## **Proposal for Supplement 14 to the 02 series of amendments to UN Regulation No. 117 (Tyre rolling resistance, rolling noise and wet grip)**

### **Submitted by the Working Party on Noise and Tyres\***

The text reproduced below was adopted by the Working Party on Noise and Tyres (GRBP) at its seventy-fourth session (ECE/TRANS/WP.29/GRBP/72, para. 21). It is based on ECE/TRANS/WP.29/GRBP/2021/17 as amended by Informal document GRBP-74-31-Rev.1. It is submitted to the World Forum for Harmonization of Vehicle Regulations (WP.29) and to the Administrative Committee (AC.1) for consideration at their March 2022 sessions.

### Examples of separate UN Regulation No. 117 approval marks

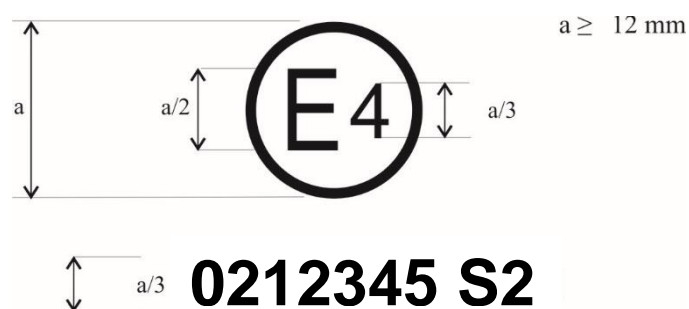
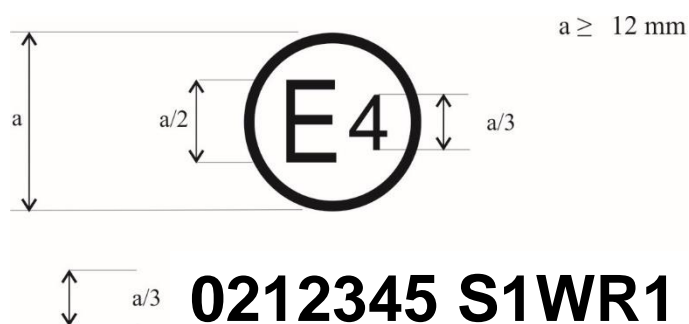
Annex 2 - Appendix 1, amend to read:

The above approval mark, affixed to a tyre shows that a tyre concerned has been approved in the Netherlands (E 4) pursuant to Regulation No. 117 (marked by "S2"), under approval number 0212345. This indicates that the approval is for rolling sound at stage 2 (S2). The first two digits of the approval number (02) indicate that the approval was granted in accordance with this Regulation which included 02 series of amendments.

The above approval mark shows that the tyre concerned has been approved in the Netherlands (E 4) pursuant to Regulation No. 117 (marked by "S1WR1") under approval number 0212345. This indicates that the approval is for rolling sound at stage 1 (S1), wet adhesion (W) and rolling resistance at stage 1 (R1). The first two digits of the approval number ("02") indicate that the approval was granted in accordance with this Regulation which included the 02 series of amendments."

**Approval according to UN Regulation No. 117 coincident with approval of UN Regulations Nos. 30 or 54**

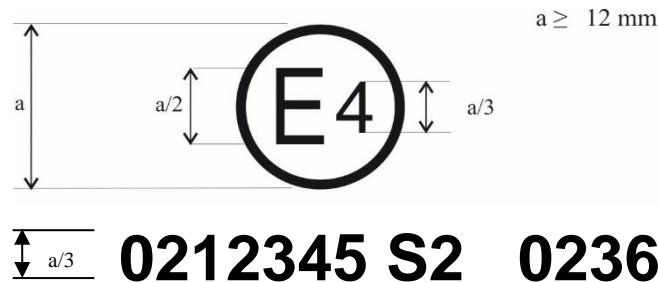
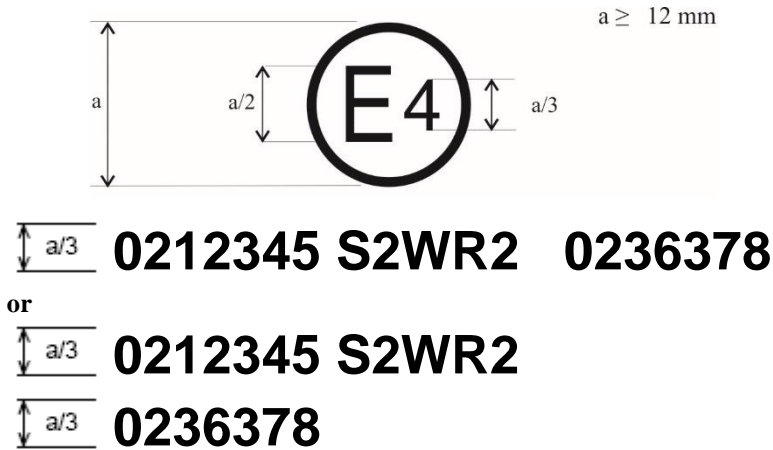
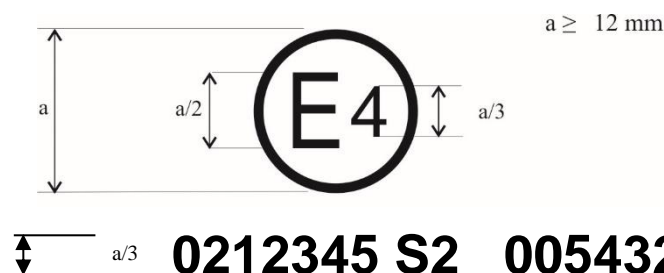
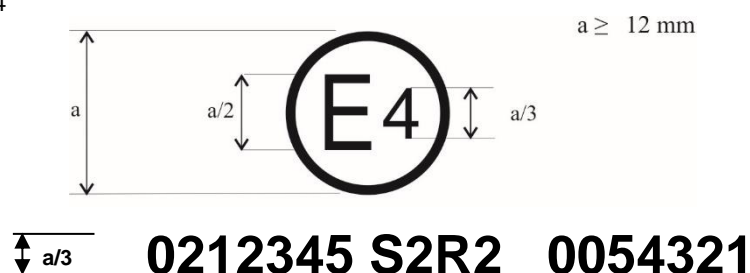
Annex 2 - Appendix 2, delete footnote 1 and amend to read:

The above approval mark shows that the tyre concerned has been approved in the Netherlands (E 4) pursuant to UN Regulation No. 117 (marked by "S2"), under approval number 0212345 and UN Regulation No. 30, under approval number 0236378. This indicates that the approval is for rolling sound at stage 2 (S2). The first two digits of the approval number ("02") in conjunction with "S2" indicate that the approval was granted in accordance with UN Regulation No. 117 which included the 02 series of amendments. The first two digits of the UN Regulation No. 30 approval number ("02") indicate that this Regulation included the 02 series of amendments.

The above approval mark shows that the tyre concerned has been approved in the Netherlands (E 4) pursuant to UN Regulation No. 117 (marked by "S2WR2"), under approval number 0212345 and UN Regulation No. 30, under approval number 0236378. This indicates that the approval is for rolling sound at stage 2 (S2), wet adhesion (W) and rolling resistance at stage 2 (R2). The first two digits of the approval number ("02") in conjunction with "S2WR2" indicate that the first approval was granted in accordance with UN Regulation No. 117 which included the 02 series of amendments. The first two digits of the UN Regulation No. 30 approval number ("02") indicate that this Regulation included the 02 series of amendments.

The above approval mark shows that the tyre concerned has been approved in the Netherlands (E 4) pursuant to UN Regulation No. 117 and the 02 series of amendments under approval number 0212345 (marked by "S2"), and UN Regulation No. 54, under approval number 0054321. This indicates that the approval is for rolling sound stage 2 (S2). The first two digits of the UN Regulation No. 117 approval number ("02") in conjunction with "S2" indicate that the first approval was granted in accordance with UN Regulation No. 117 which included the 02 series of amendments. The first two digits of the UN Regulation No. 54 approval number ("00") indicate that this Regulation was in its original form.

The above approval mark shows that the tyre concerned has been approved in the Netherlands (E 4) pursuant to UN Regulation No. 117 and the 02 series of amendments under approval number 0212345 (marked by "S2R2"), and UN Regulation No. 54, under approval number 0054321. This indicates that the approval is for rolling sound stage 2 (S2) and rolling resistance stage 2 (R2). The first two digits of the UN Regulation No. 117 approval number ("02") in conjunction with "S2R2" indicate that the first approval was granted in accordance with UN Regulation No. 117 which included the 02 series of amendments. The first two digits of the UN Regulation No. 54 approval number ("00") indicate that this Regulation was in its original form."

### Combinations of markings of approvals issued in accordance with UN Regulations Nos. 117, 30 or 54

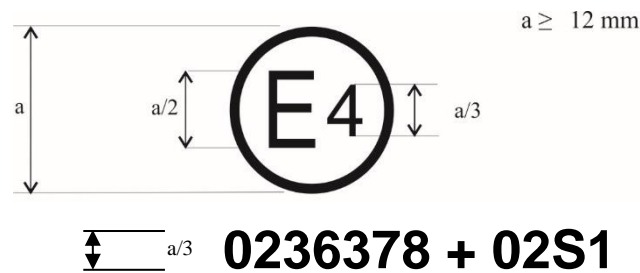
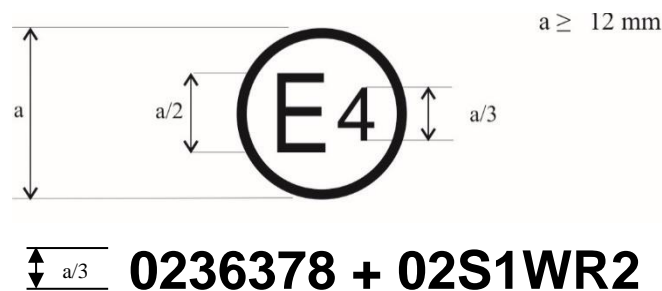
Annex 2 - Appendix 3, amend to read:

The above approval mark shows that the tyre concerned has been approved in the Netherlands (E 4) pursuant to UN Regulation No. 30 according to its 02 series of amendments (indicated by the first two digits of the approval number, "02") under approval number 0236378. It is also marked by "+ 02S1" which indicates that the tyre was also approved pursuant to UN Regulation No. 117 (02 series of amendments) for rolling sound at stage 1.

The above approval mark shows that the tyre concerned has been approved in the Netherlands (E 4) pursuant to Regulation No. 30 according to its 02 series of amendments (indicated by the first two digits of the approval number, "02") under approval number 0236378. It is also marked by "+ 02S1WR2" which indicates that the tyre was also approved pursuant to UN Regulation No. 117 (02 series of amendments) for S1 (rolling sound at stage 1), W (wet adhesion) and R2 (rolling resistance at stage 2)."

### Extensions to combine approvals issued in accordance with Regulation No. 117

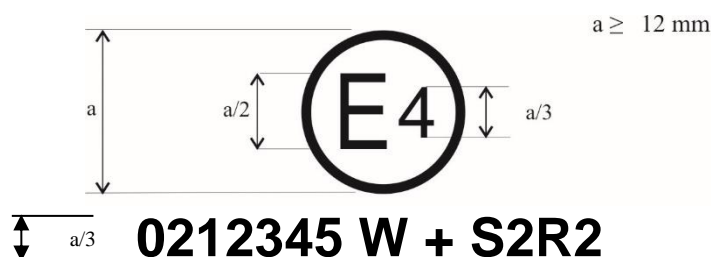
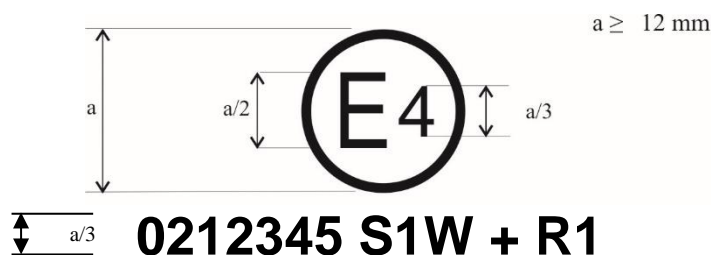
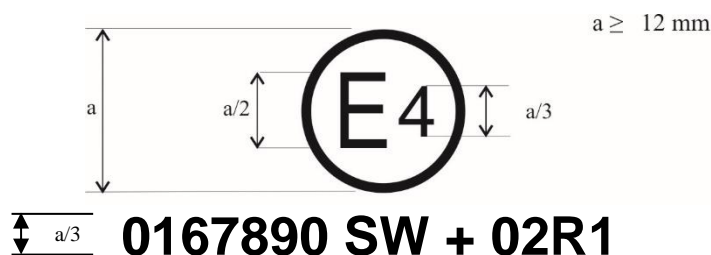
Annex 2 - Appendix 4, delete footnote 1 amend to read:

The above approval mark shows that the tyre concerned has been initially approved in the Netherlands (E 4) pursuant to UN Regulation No. 117 according to its 02 series of amendments (indicated by the first two digits of the approval number, "02") under approval number 0212345 (marked by "W"). This indicates that the approval is for W (wet adhesion). The "S2R2" preceded by "+" indicates that its approval has been extended under UN Regulation No. 117 to rolling sound at stage 2 and rolling resistance at stage 2 based on separate certificate(s).

The above approval mark shows that the tyre concerned has been initially approved in the Netherlands (E 4) pursuant to UN Regulation No. 117 according to its 02 series of amendments (indicated by the first two digits of the approval number, "02") under approval number 0212345 (marked by "S1W"). This indicates that the approval is for S1 (rolling sound at stage 1) and W (wet adhesion). The "R1" preceded by "+" indicates that its approval has been extended under Regulation No. 117 to rolling resistance at stage 1 based on separate certificate(s).

The above approval mark shows that the tyre concerned has been initially approved in the Netherlands (E 4) pursuant to UN Regulation No. 117 according to its 01 series of amendments (indicated by the first two digits of the approval number, "01") under approval

number 0167890 (marked by "SW"). This indicates that the approval is for S (rolling sound at stage 1) and W (wet adhesion). The "02R1" preceded by "+" indicates that its approval has been extended under UN Regulation No. 117 according to its 02 series of amendments to rolling resistance at stage 1 based on separate certificate(s)."
